RFI Response - Noise

Job No.:	70B-22-0096	Doc. No:	78653-0-draft
Attention:	Gary Peacock	Author:	Patrick Drake
Company:	Outline Planning Consultants Pty Ltd	Reviewed by:	N/A
Email:	gpeacock@outline.com.au	Issued by:	[Issuer's name will appear here]
Subject:	RFI Response - Noise

The following letter is in response to the request for additional information issued on the 8th of May, 2024 by Gunnedah Shire Council in relation to the development application No. 2023/046 for the proposed lateral expansion of 'Bolgers Pit' (809 Oakey Creek Road, Piallaway). This letter should be read in conjunction with the revised Noise and Vibration Impact Assessment (report ref: 70B-22-0096-TRP-36720-4) dated 24th of June, 2024.

Bolgers Pit

Figure 6-1 - Haul Routes

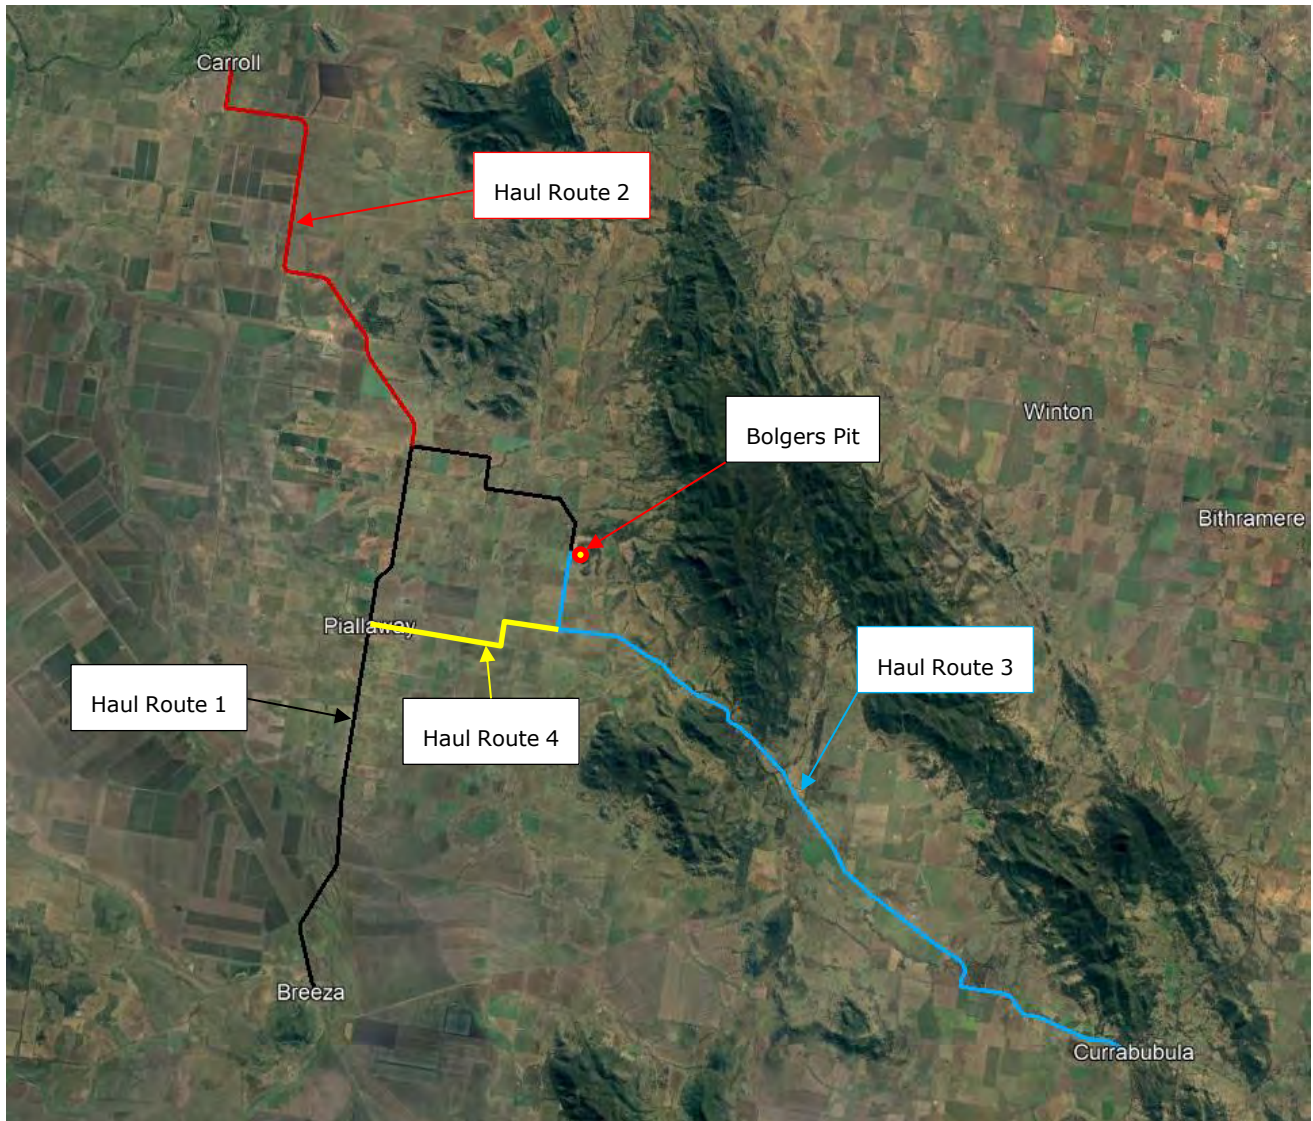
a) The Noise Impact Assessment is to be updated to consider traffic noise generated along Denver Lane should it be included within the vehicle haul route.

Although it is not part of the proposal, Denver Lane has been included in the haul route traffic noise assessment in Section 6 of the revised report. The associated Traffic Impact Assessment has not included Denver Lane as part of its survey, therefore appropriate assumptions surrounding expected AADT values have been used as a result. Haul route noise impacts along Denver Lane are predicted to comply with the relevant criteria without the need for acoustic mitigation.
